ADDENDA

SPECIFICATION NO. 26-11762-C

1947 CENTER ST. WINDOW REPLACEMENT PROJECT

ADDENDUM NO. 2

PARTIAL BASEMENT PLAN

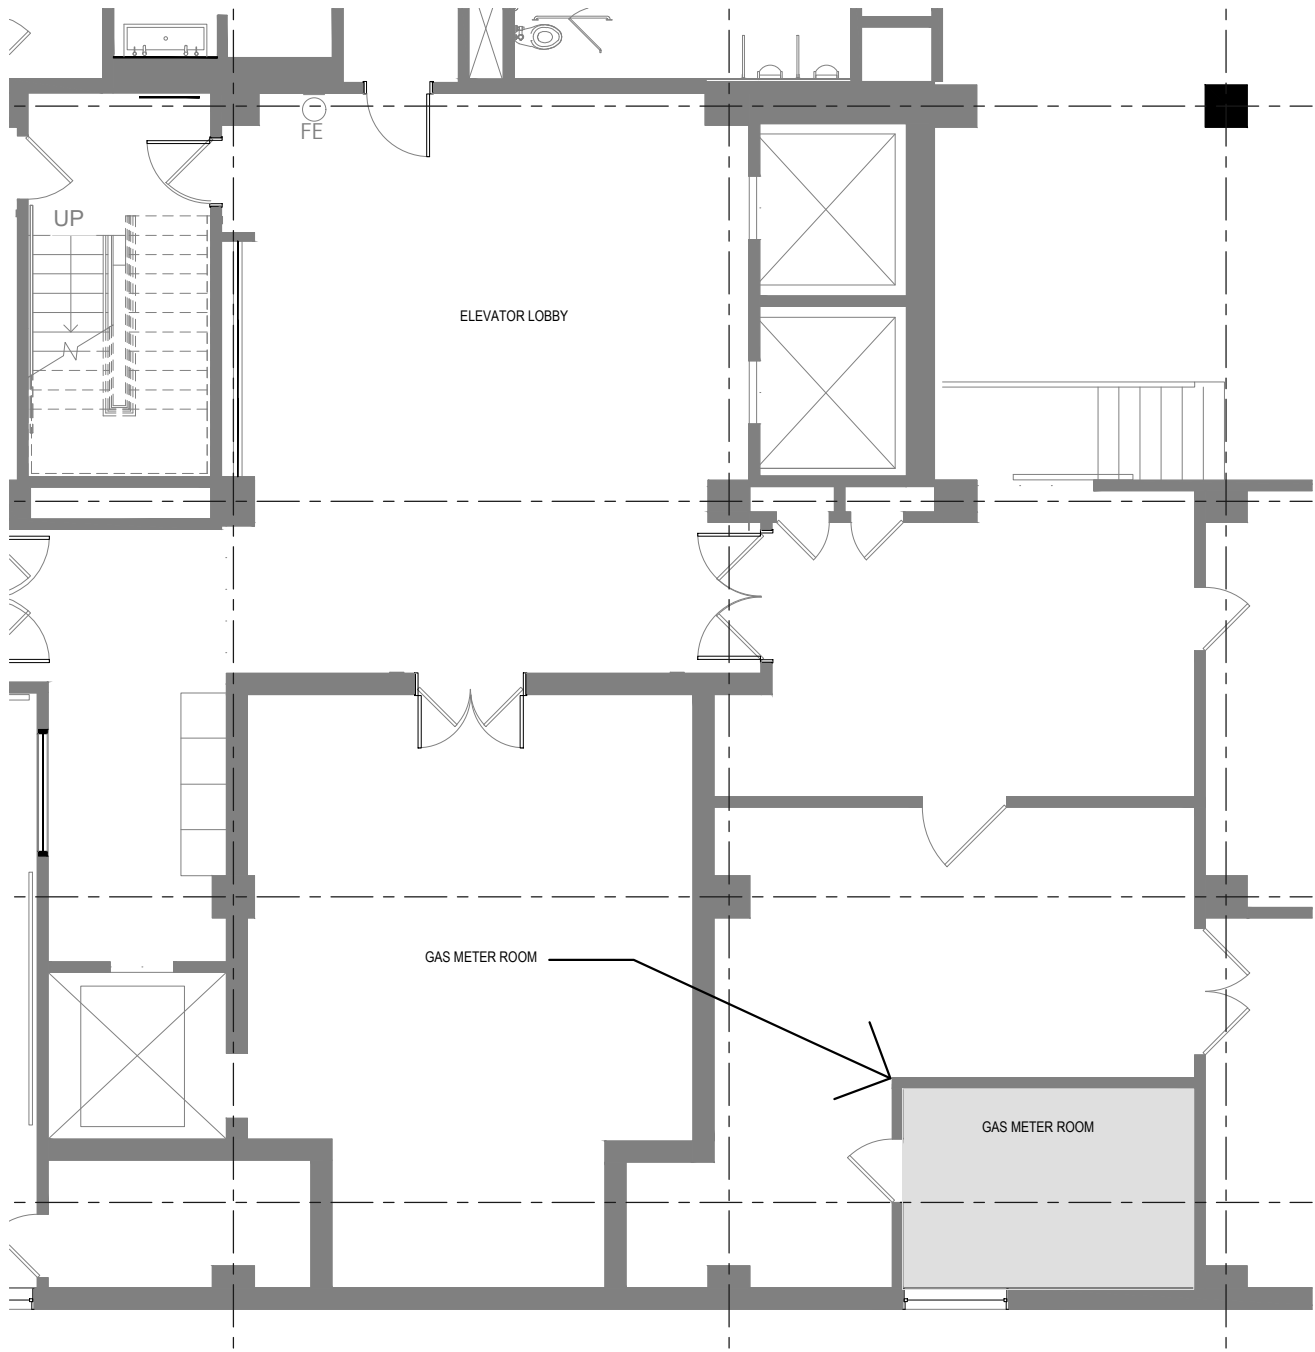
Furnish and install a 4-inch diameter automatic seismic valve on the gas supply to the building on the customer side of the existing natural gas PG&M meter. Provide additional shutoff valve as indicated on the attached sketch. The gas meter is located in gas meter room in the basement. See attached sketches and cut sheet for the seismic valve.

SCOPE OF WORK: FURNISH AND INSTALL AUTOMATIC GAS SEISMIC VALVE ON THE CUSTOMER SIDE OF THE PG&E GAS METER. LOCATE SEISMIC VALVE TO THE 4" RISER WITH SHUTOFF VALVE.

GAS METER PIPING ELEVATION

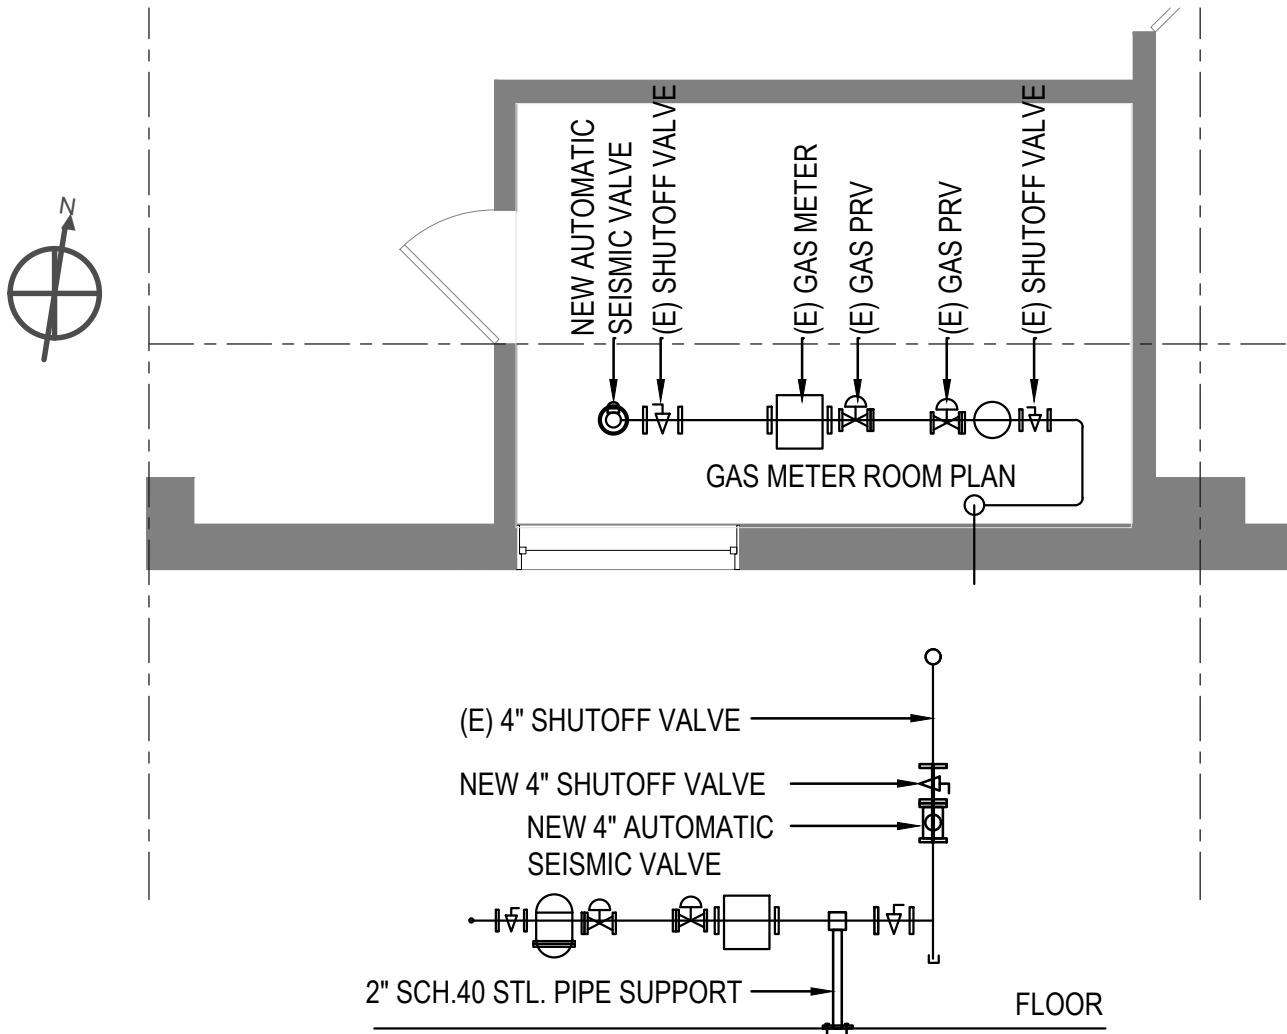
SCOPE OF WORK: FURNISH AND INSTALL AUTOMATIC GAS SEISMIC VALVE ON THE CUSTOMER SIDE OF THE PG&E GAS METER. LOCATE SEISMIC VALVE TO THE 4" RISER WITH SHUTOFF VALVE. PROVIDE ADDITIONAL PIPE SUPPORT WITH 2" SCHEDULE 40 BLACK STEEL PIPE WITH (4) 1/2" EXPANSION SHIELD ANCHOR BOLTS, 3" EMBEDMENT.

1. AUTOMATIC SEISMIC VALVE: ANSI Z21.21 PACIFIC SEISMIC PRODUCT MODEL VB-316f(60) RAISE FACE FLANGED VALVE.
2. SHUTOFF VALVE: NORDSTROM LUBRICATED PLUG VALVE 120, ASME 150 PRESSURE CLASS, RAISED FACE FLANGED ENDS (ASME 16.5), WRENCH SQUARE-NUT OPERATOR, CARBON STEEL BODY, CARBON STEEL BOLTED COVER WITH LOCKING DEVICE FOR NATURAL GAS SERVICE.
3. PIPING: BLACK STEEL PIPE, SCHEDULE 40 WELDED JOINTS ASTM A53, CLASS 150 FLANGES ANSI B16.1. GASKET MATERIAL SUITABLE FOR NATURAL GAS.
4. GAS PIPING SHALL COMPLY WITH NFPA 54 AND CALIFORNIA PLUMBING CODE 2025.
